The Panel
Waihi North Project Fast-track Application
FTA-2504-1046

**RE: Request for information in relation to the Waihi North Project under the Fast-track Approvals
Act 2024**

**OCEANA GOLD (NEW ZEALAND) LIMITED
WAIHI NORTH PROJECT
FAST TRACK APPROVALS ACT APPLICATION
RESPONSE TO REQUEST FOR INFORMATION ON STORAGE 3 TAILINGS
STORAGE FACILITY (TSF3)**

FIGURE 04

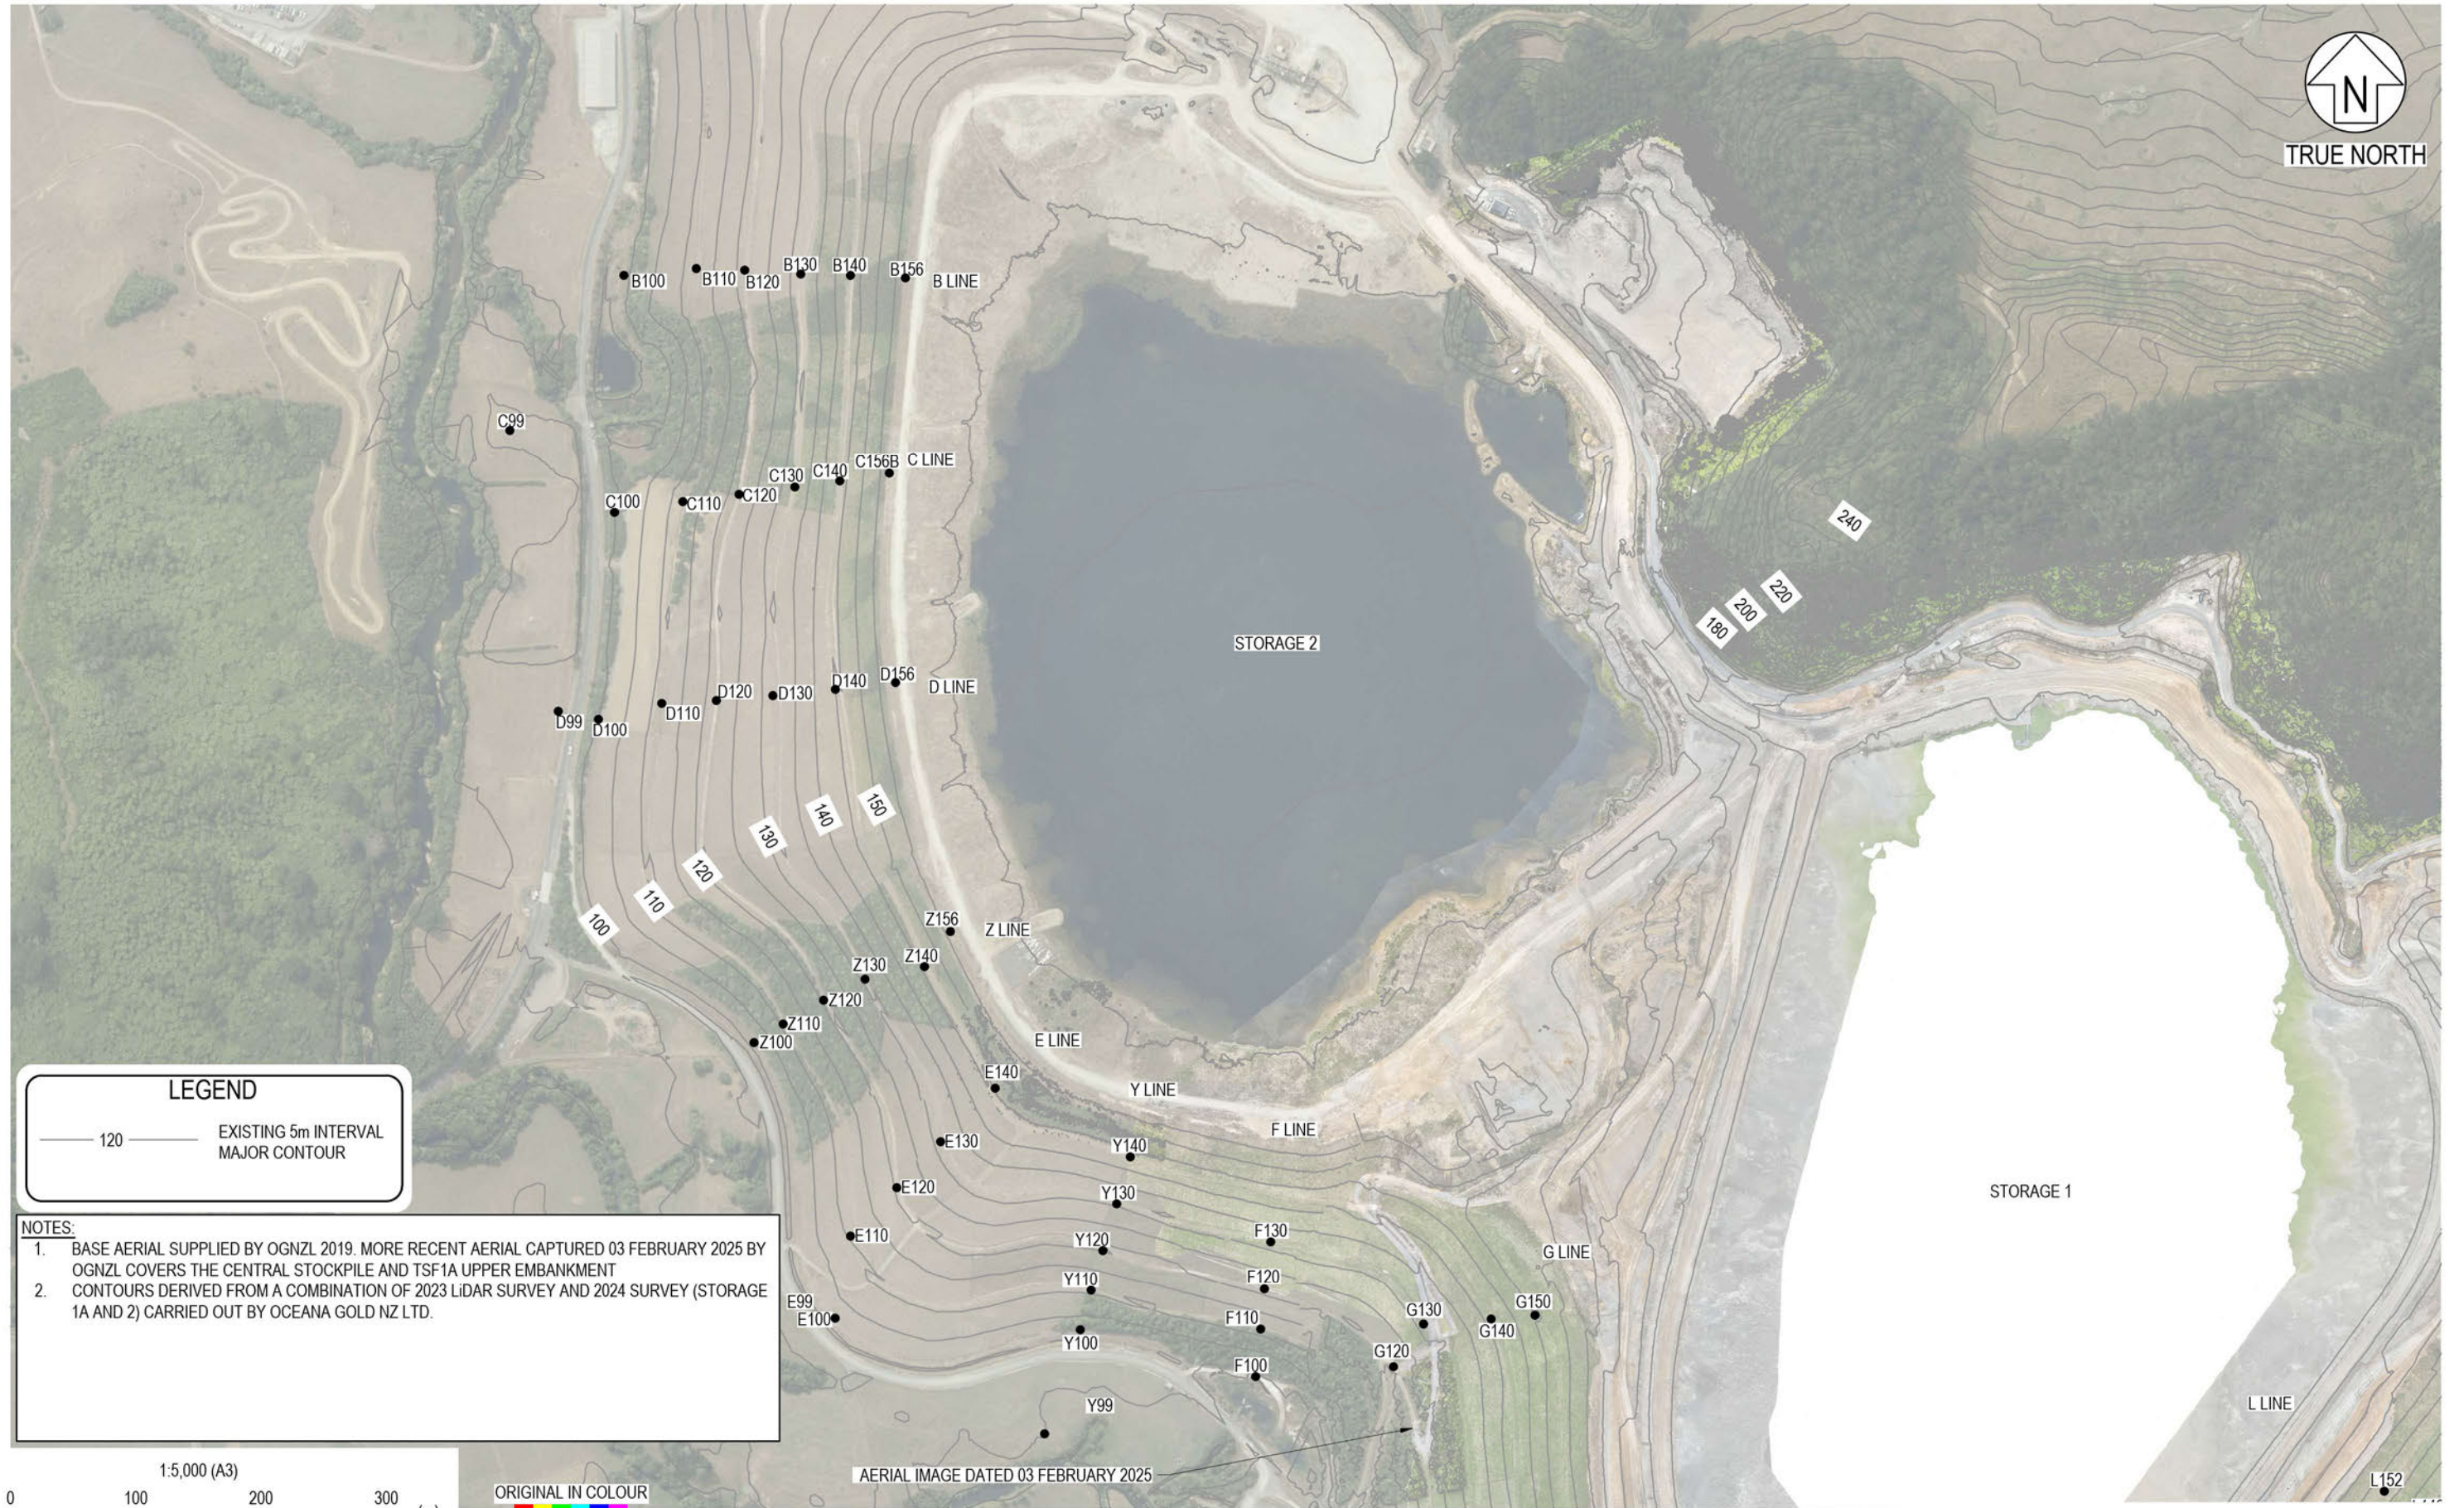
Coromandel Watchdog commented that accurate monitoring of existing waste rock piles and tailings facilities was needed. OGNZL responded that these sites are extensively instrumented, however there is no information provided that summarises the outcomes of that monitoring. Performance of the existing rock stacks and tailings areas is pertinent to the expected performance of future rock stacks and tailings areas. Please provide a summary of the outcomes of monitoring of Tailings Storage 1A and 2 and existing rock stacks.

- In regard to dam safety and structural integrity:
 - TSF1A has 26 deformation benchmarks installed as shown on Figure 3 attached.
 - TSF2 has 41 deformation benchmarks installed as shown on Figure 4 attached.

- The visual monitoring and deformation survey indicates both TSFs are stable with very small deformations. This is attributed to the rigorous specifications for fill placement and compaction within the zoned embankments.
